Appendix B

DOH Sanitary Survey

November 2, 2017 Mike Peterson City of Woodland Post Office Box 9 Woodland, Washington 98674	City of Woodland ID #982002	
	County:	Cowlitz
	System Type:	Community
	Operating Permit Color:	Green
	Surveyors:	Teresa Walker Fern Schultz
	Inspection Date:	September 21, 2017

Corrosion on filter housings

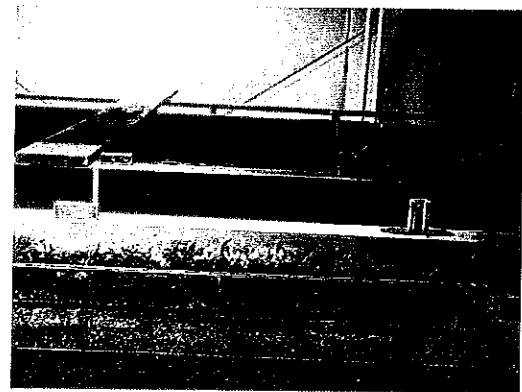
5. The filter housings for filters 1 and 2 are severely corroded and in need of painting. Please plan to paint or replace the filter housings within the next three years.

Most of the recommendations from the 2008 CPE have been implemented, including equipment replacements. Gray and Osborne also completed an evaluation of plant needs in 2017. **The filter housings for the two oldest filters (1 and 2) are in need of rehabilitation and/or replacement as they are severely corroded.**

Kuntze K400 analyzer

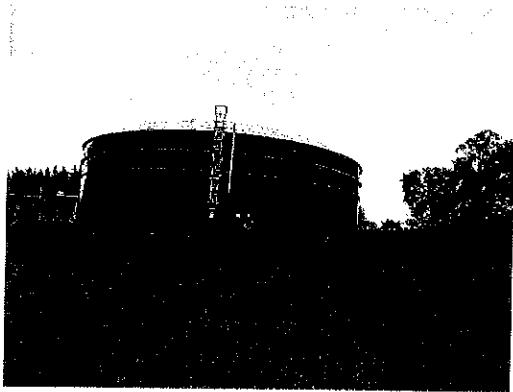
Chlorine samples from the 1.1 MG reservoir are pumped to the treatment plant and sampled continuously along with pH and temperature with a reagentless Kuntz K400 analyzer. The lowest residual of the day is reported on the monthly reporting form for calculating contact time. Operators have noted troubles in calibrating this analyzer.

A CL17 monitors chlorine residual out of the clearwell. The CL17 is checked with a colorimeter bench test weekly. HACH reps come out twice a year to calibrate instrumentation. They have had some trouble with verification and calibration of the K400.

1.1 MG glass lined reservoir

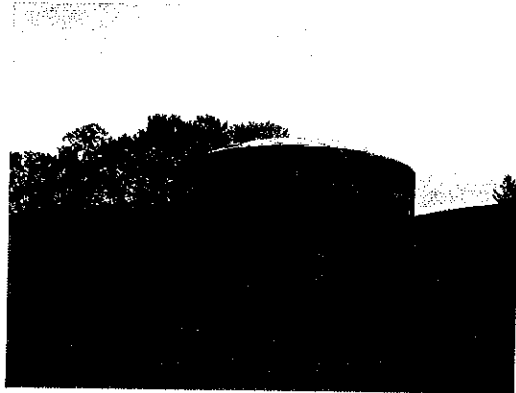
Please provide photos of screened air vents and hatch sealing gaskets for both reservoirs. Drains and overflows flow into a common manhole with a duckbill type of valve. The manhole discharges to a ditch below the facility. The concrete reservoir has an internal baffle.

Reservoirs should be cleaned and inspected every five years. Please incorporate this maintenance into your ongoing operations and maintenance (O&M) plans. The reservoirs should be climbed annually to inspect the roof vents, hatches, and general condition.
